SERVICE BULLETIN No.1152

COACH MODEL	: C2045
BULLETIN TYPE	: Safety Recall Program -- NHTSA Campaign number 04V-423
MANUAL & SECTION	: N/A
DATE	: December 3, 2004
SUBJECT	: Air tank retention
TERMS & CONDITIONS	: Refer to the Warranty Information in this Bulletin.

Figure 1a: Air tank bolt-on assembly – drive axle area

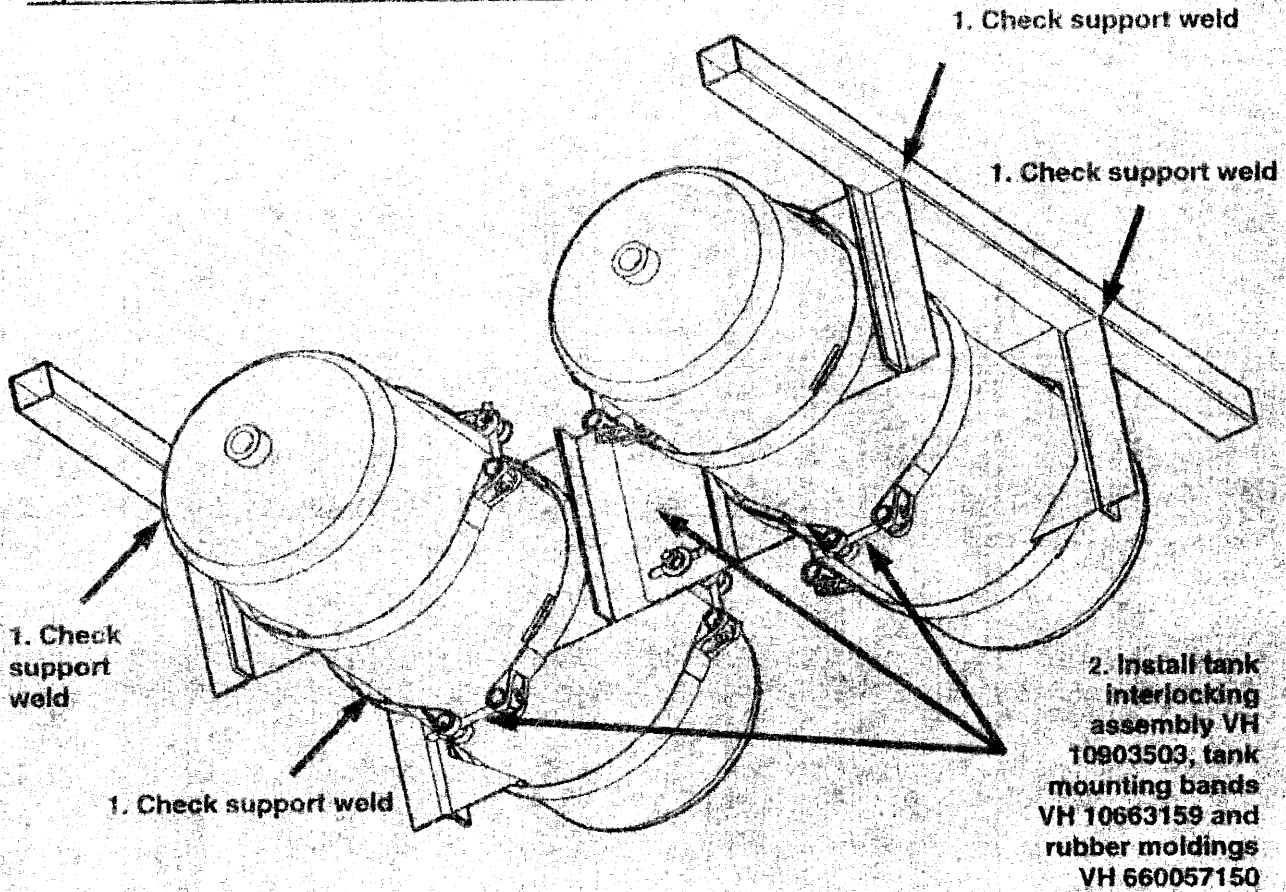
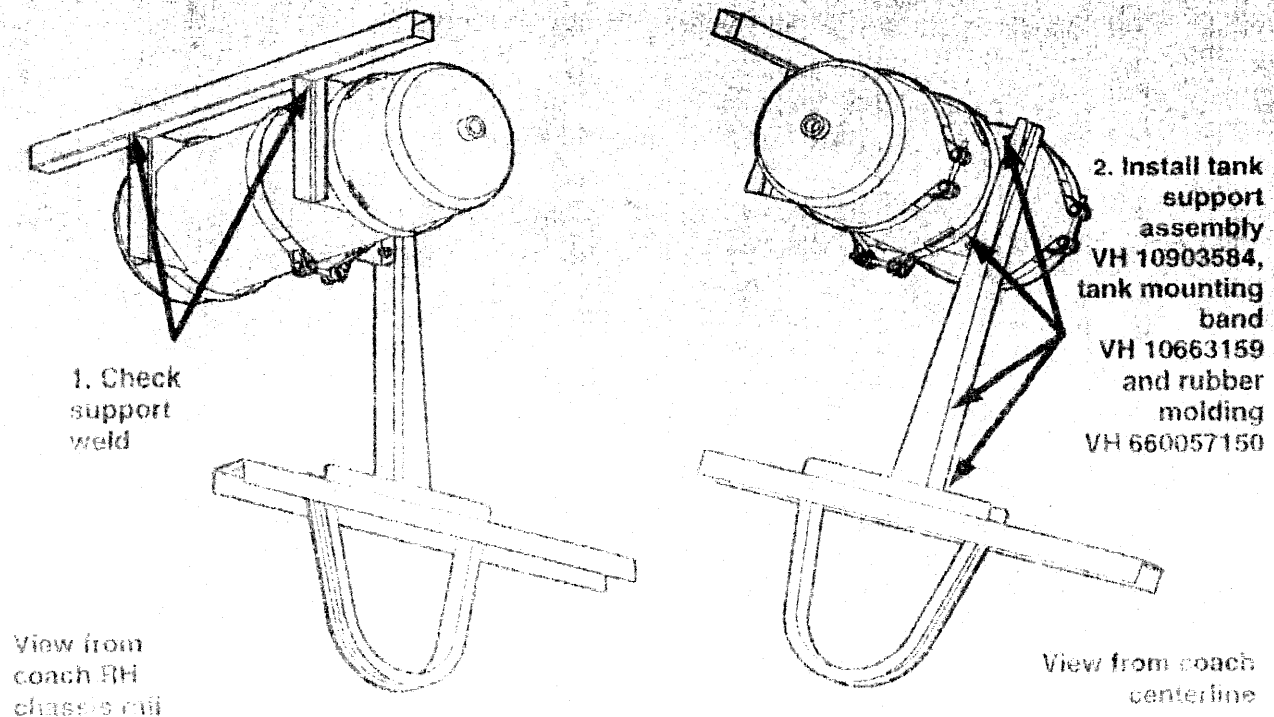
1. On the above-mentioned coaches, it is necessary to check the air tank retention and to install additional support brackets to ensure that the air tanks listed hereafter remain properly secured to the chassis.

2. This Service Bulletin offers a bolt-on solution to address the issue. Refer to the parts list and the procedure, which provide the information required to complete the repair.

- 1) Using a flashlight, inspect the area where the air tank support brackets have been welded to the chassis rails (see Figures 1a and 10).

Figure 2: Tank interlocking assembly VH 10903503 for auxiliary and drive axle service brake tanks

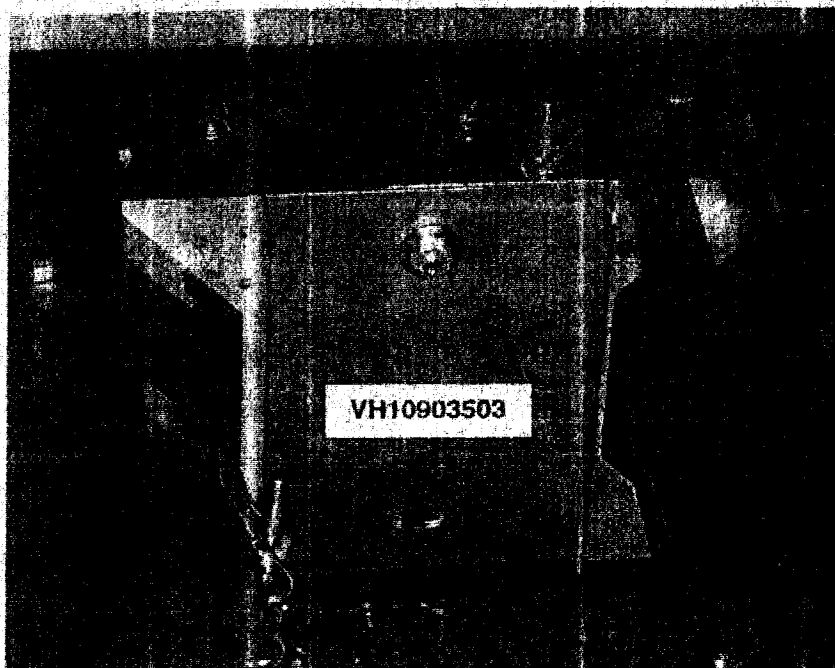
Bolt-on repair assemblies – order as kit VH 10907587 (see Figures 1, 2 and 3):

Figure 7: Air tank location

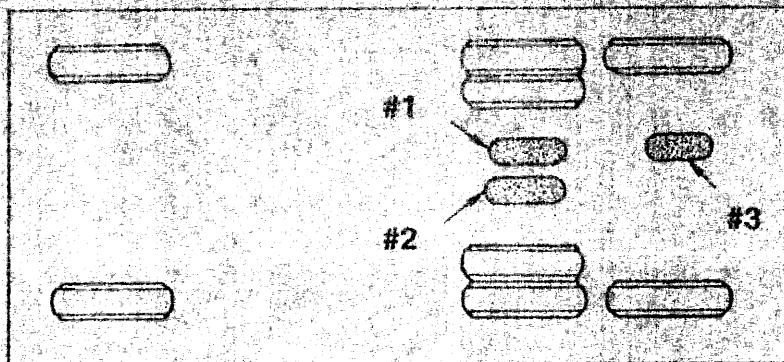
Tank	Location	Refer to
#1 Auxiliary	Above drive axle	1, Figure 7 (page 5 of 10)
#2 Drive axle service brake	Above drive axle	2, Figure 7 (page 5 of 10)
#3 Tag axle brake	Above tag axle	3, Figure 7 (page 5 of 10)

- 4) Locate the affected air tanks (see 1, 2 and 3, Figure 7, Figure 8 and Figure 9).

Figure 11: Air tank interlocking assembly installation

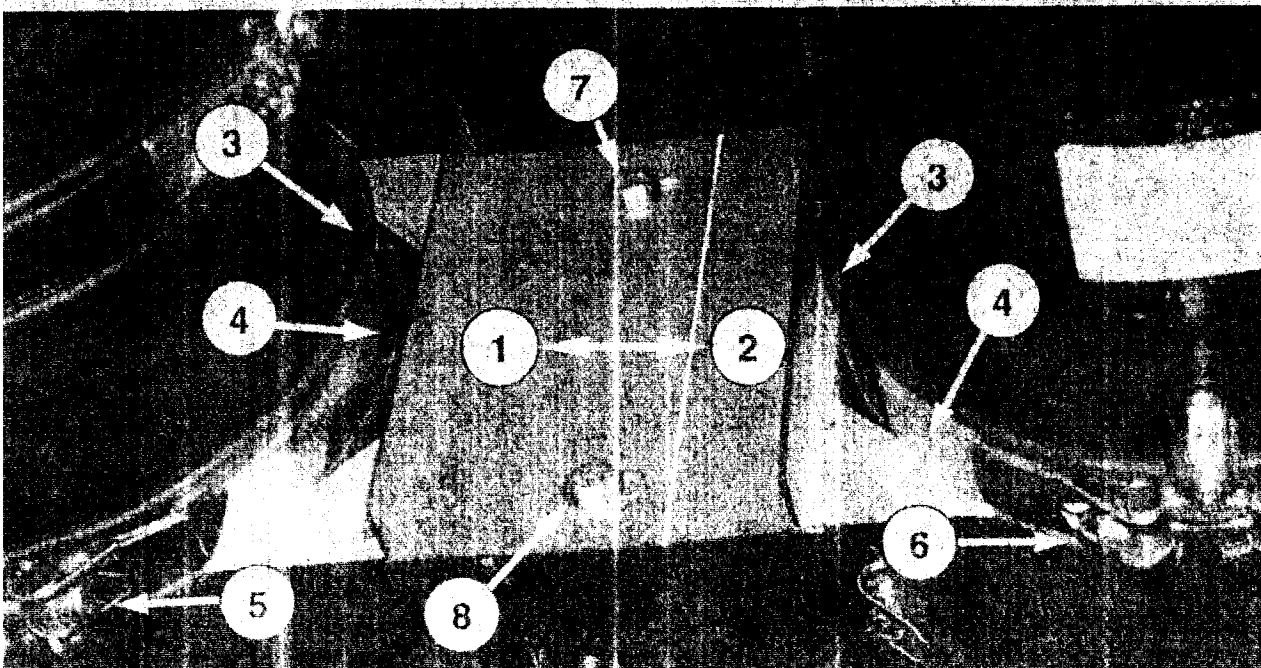
6. Air tanks #1 and #2 - To install additional interlocking assembly VH 10903503

- 1) Assemble the interlocking assembly halves and the accompanying fasteners for a loose fit.
- 2) Install the interlocking assembly between both air tanks (1 and 2, Figure 11).
- 3) Using two tank mounting bands and rubber moldings (3 and 4 Figure 11), secure each one of the interlocking assembly halves to tank #1 and tank #2 respectively. Secure the bands hand tight with the Allen bolts (5 and 6, Figure 11). Figure 12 shows one half of the assembly.
- 4) Tighten interlocking assembly bolts (7 and 8, Figure 11) to a torque of 15 ft.lbf (20 Nm).
